ADDENDUM NO. 01

DATE 06.19.2014

PROJECT VMDO Project No.1115, Renovation of Three Residence Halls
PC# 217-17565-001

M301D

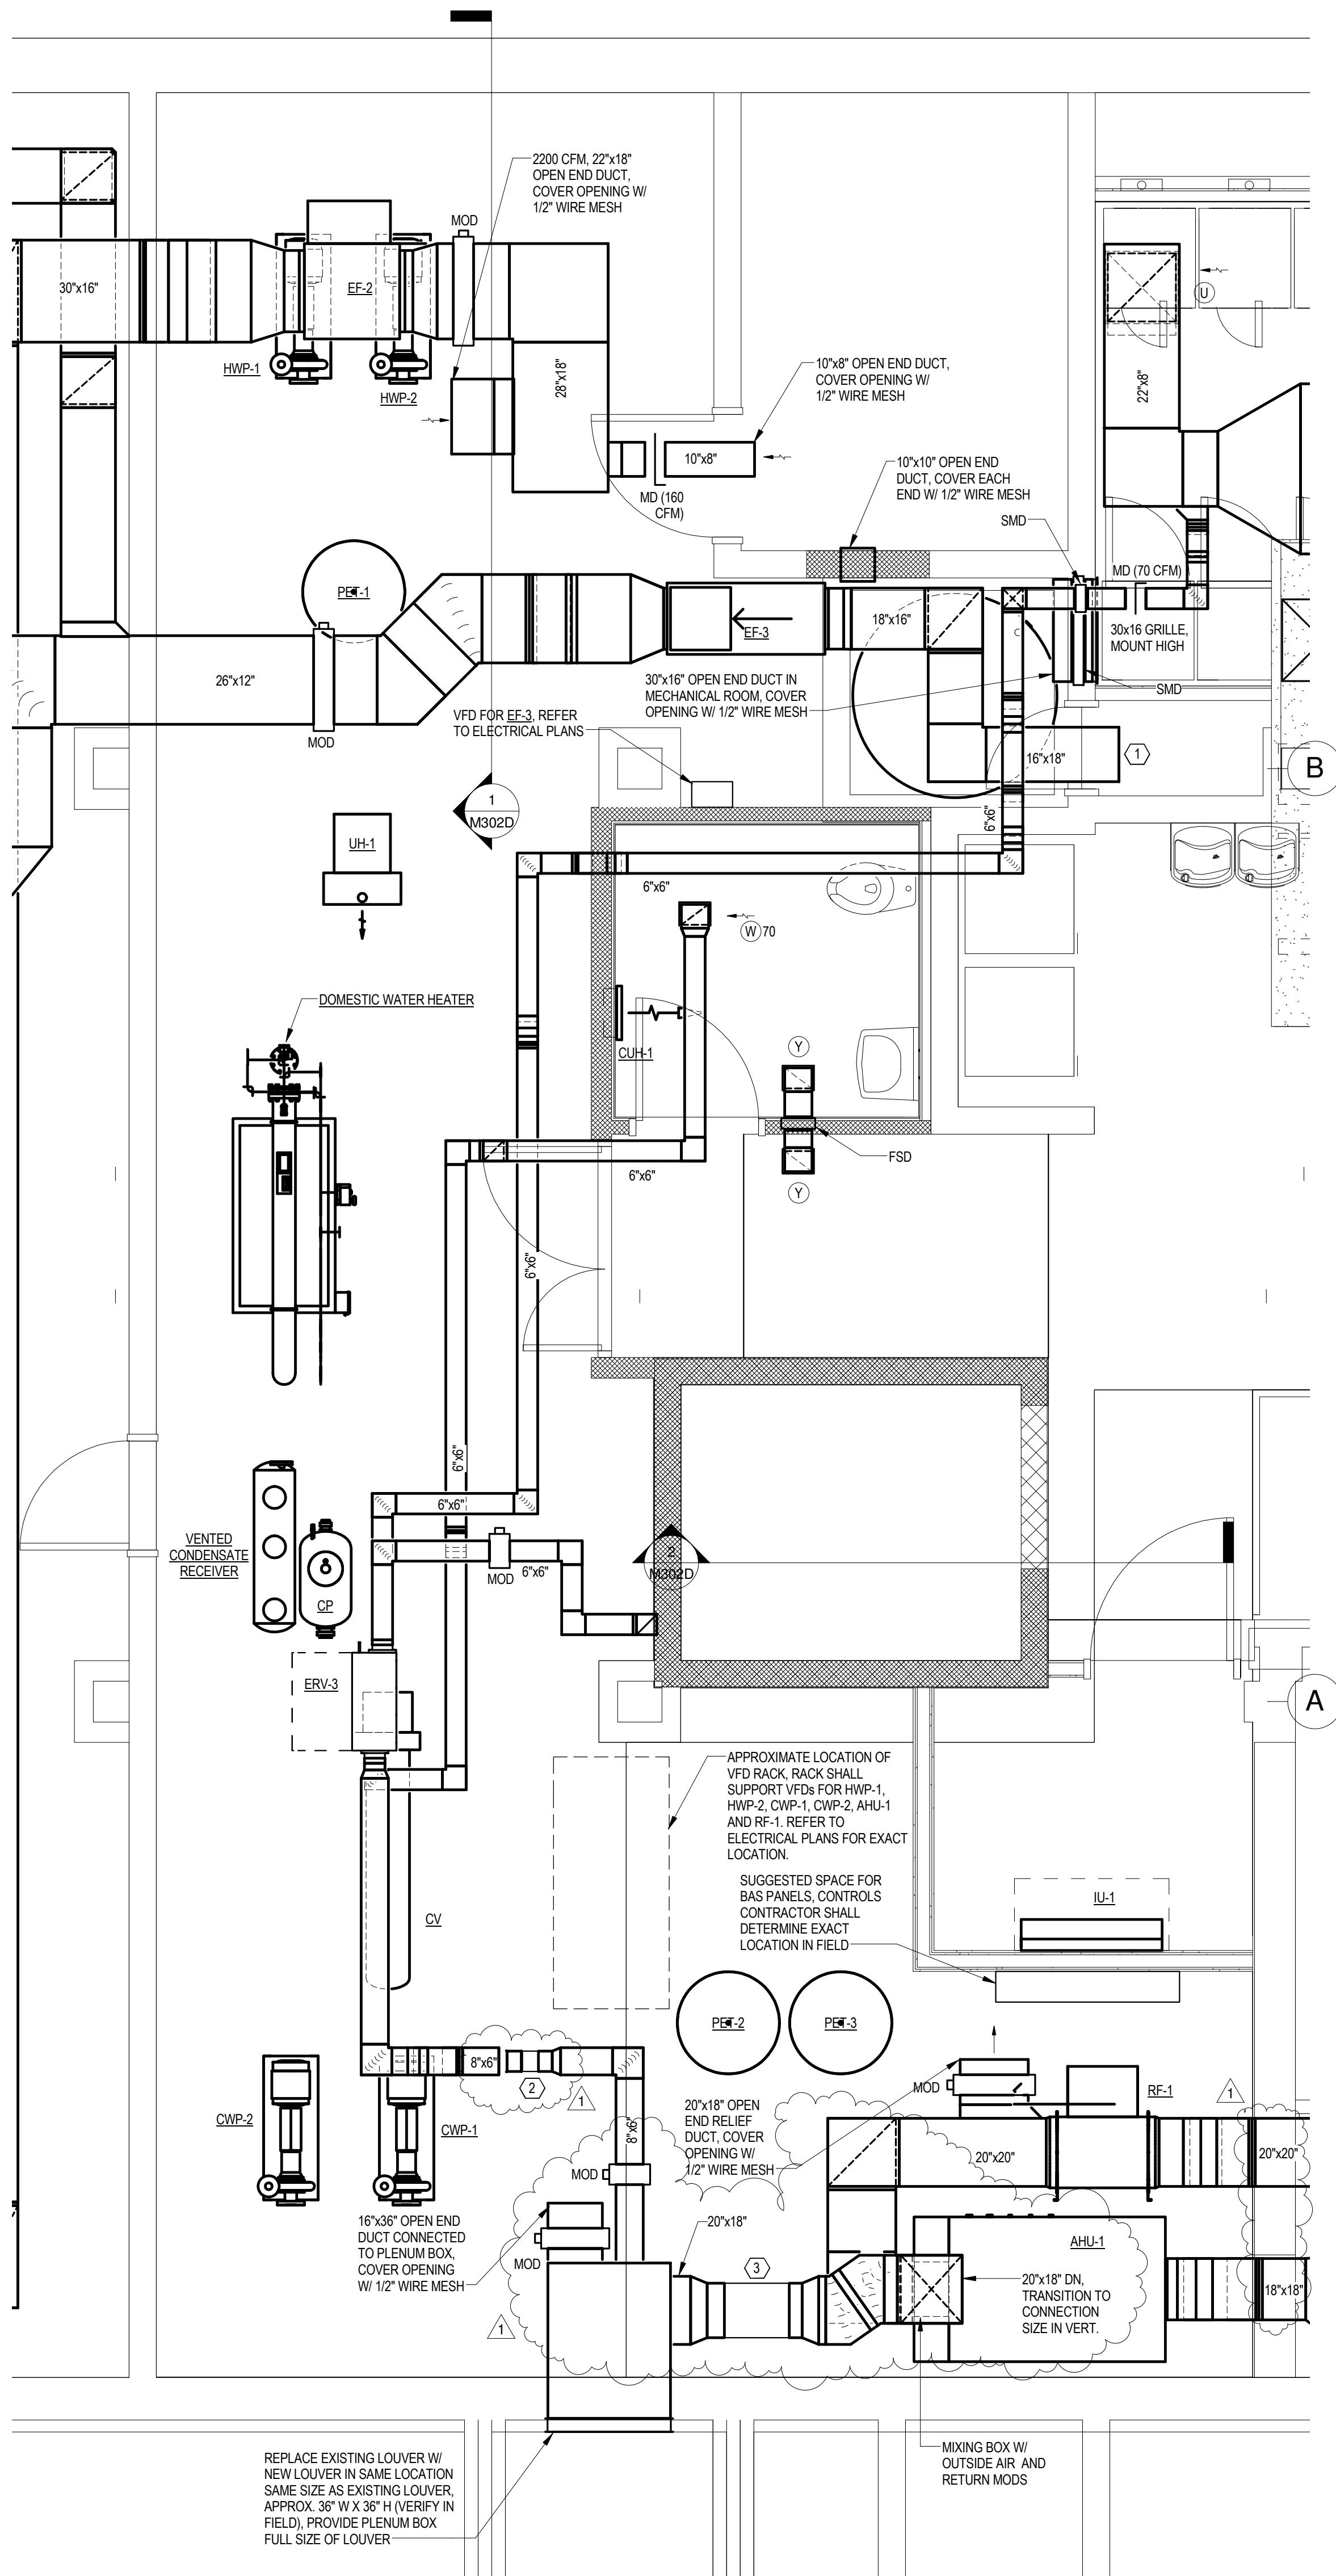
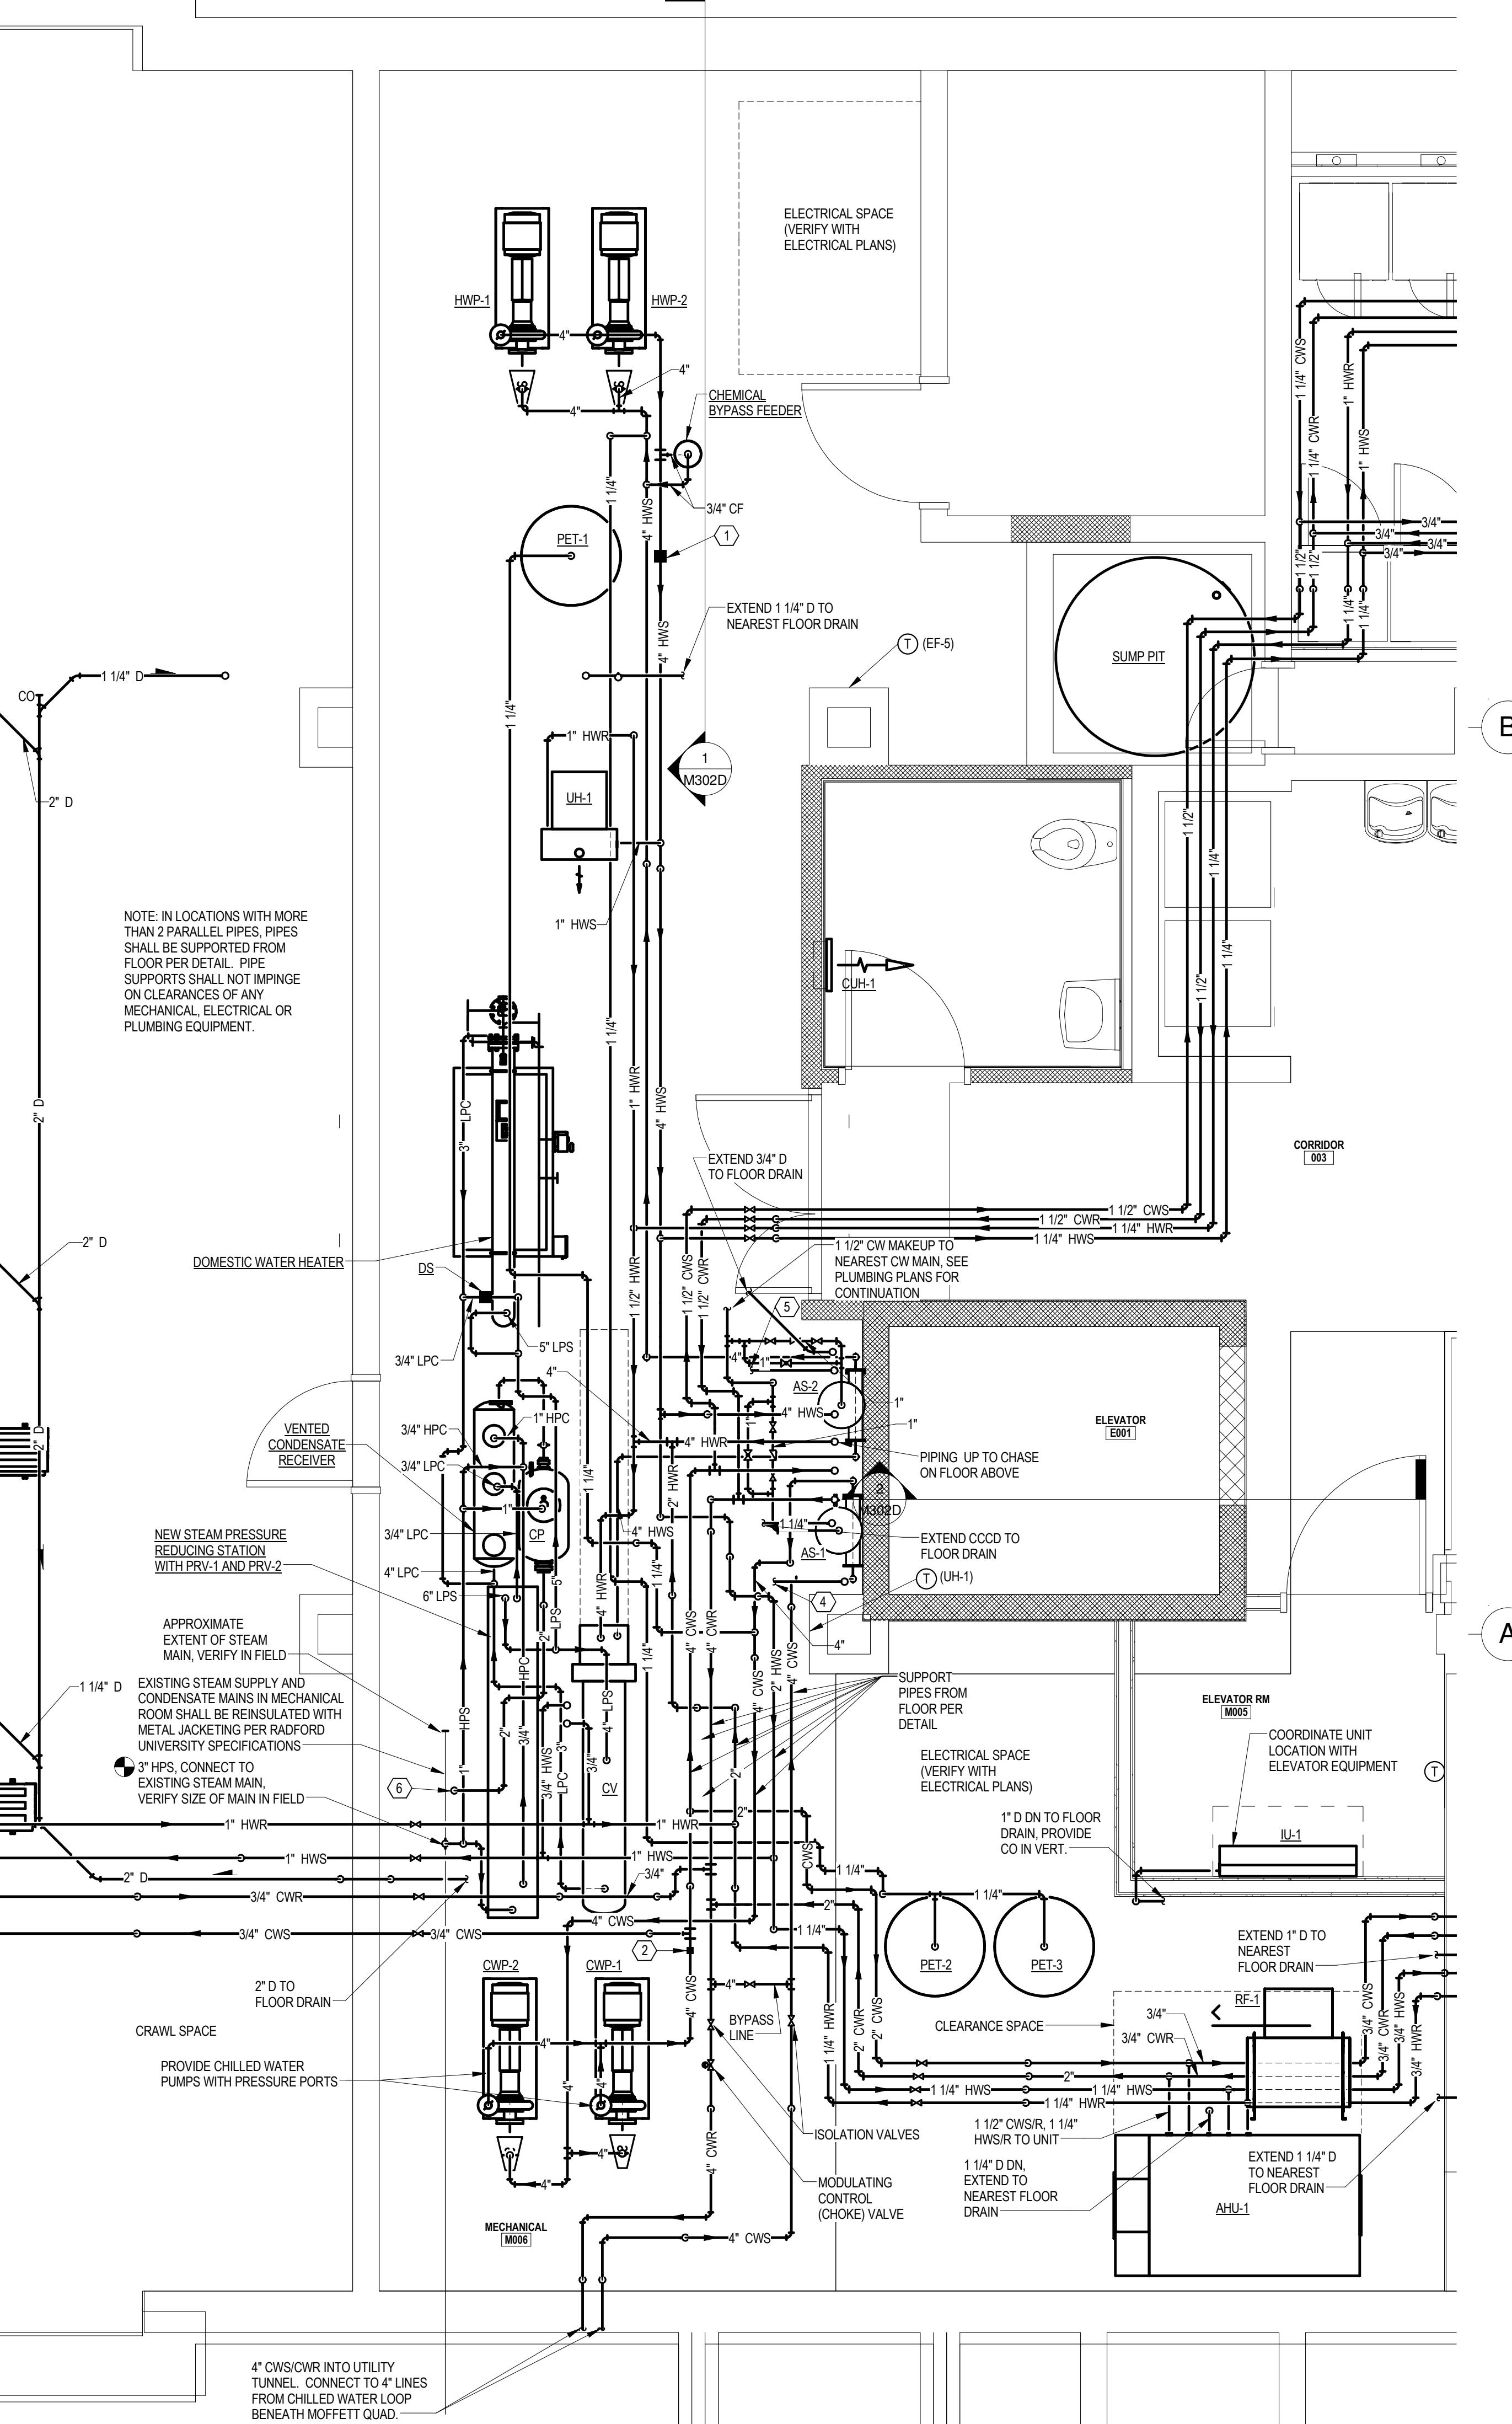
2.35 Remove fire dampers and added ductwork sizes to AHU-1 ductwork. Refer to attached revised drawing **M301D**.

2.36 Add airflow measuring station in AHU-1 outside air ductwork and modified plenum box size and duct routing. Refer to attached revised drawing **M301D**.

2.37 Add airflow measuring station in ERV-3 outside air ductwork. Refer to attached revised drawing **M301D**.

2.38 Note 3/8" graphic scale on revised drawing **M301D**.
